**Kundeninformation Mintex****ENGLISH VERSION ON PAGE 2****MDB2418 / MDB3106 → WVA 23312**

**Customer information Mintex**

**MDB2418 / MDB3106 ➔ WVA 23312**

**MDB2418**

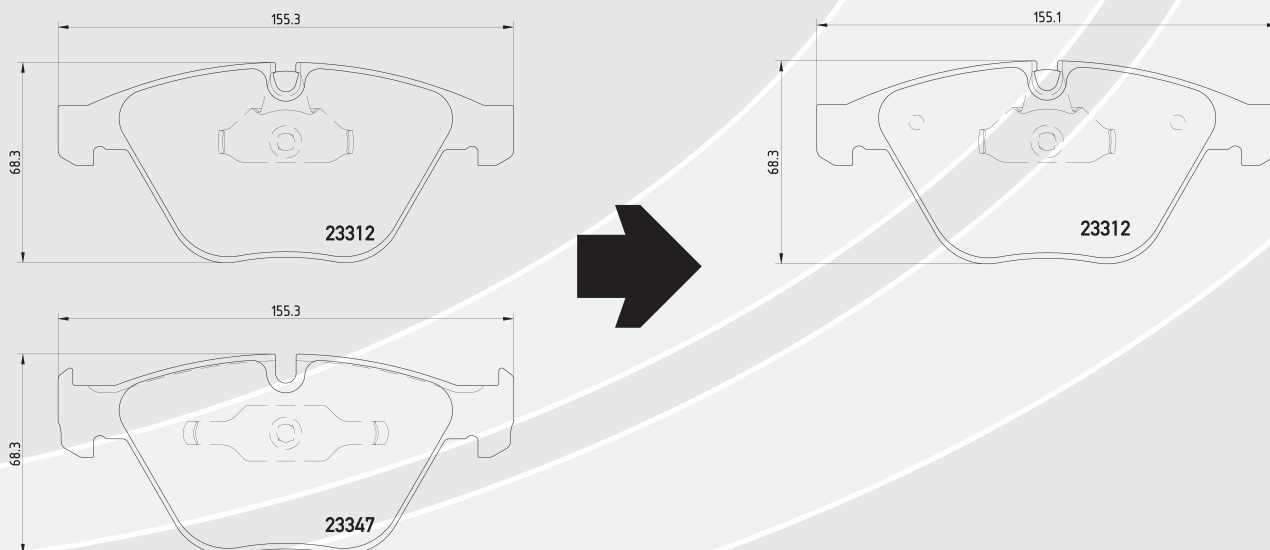
Aufgrund der Ersetzungen die im OES Bereich bei BMW erfolgt sind, sind einige Anpassungen bei den Artikeln MDB2418 und MDB3106 notwendig. Für die M-Modelle der 1er (E82) und 3er (E90-E93) Serie wird weiterhin MDB2418 verwendet. Alle anderen Modelle werden nun durch MDB3106 abgedeckt. MDB3106 ist somit auch rückwirkend für alle verknüpften Fahrzeuge einsetzbar.

BMW M-Modelle 1er (E82) und 3er (E90-E93) Serie:

**MDB2418 ➔ MDB3106**

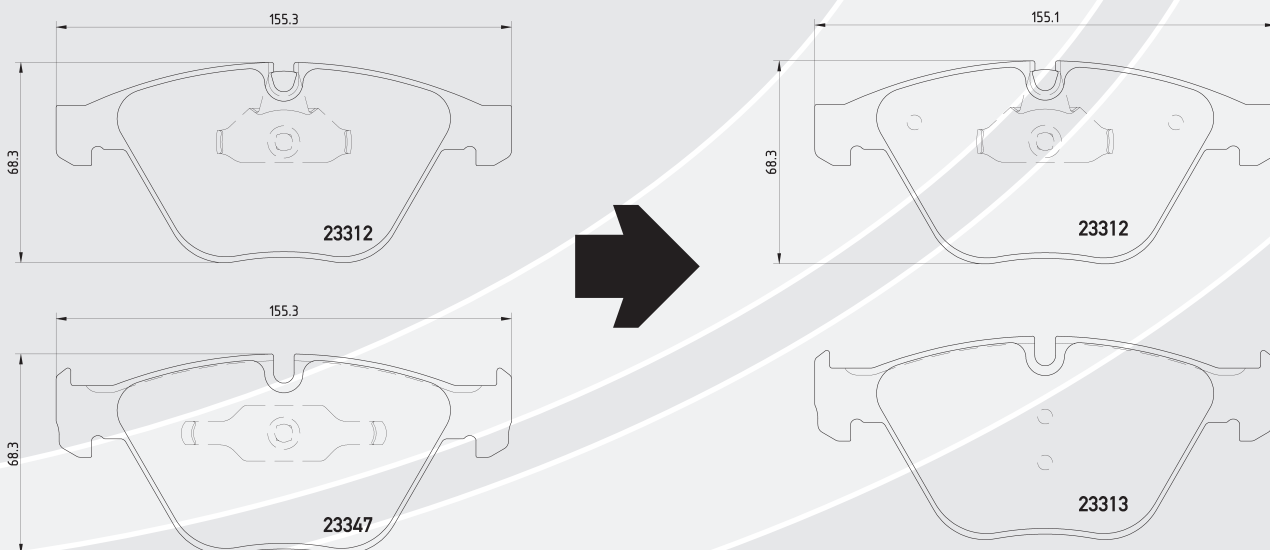
Due to changes on OES side of BMW some amendment need to be done for references MDB2418 and MDB3106. For M-models of the BMW 1-Series (E82) and 3-Series (E90-E93) you can keep using MDB2418. All other vehicles, which used to be covered by MDB2418, will now be covered by MDB3106. Therefore MDB3106 is also applicable retrospectively for all other linked vehicles.

BMW 5-Series (E60,E61), 6-Series (E63,E64) and 7-Series (E65,E66) Serie:

**Difference between both is the missing spring on the finger side pad (23347 vs. 23313)**
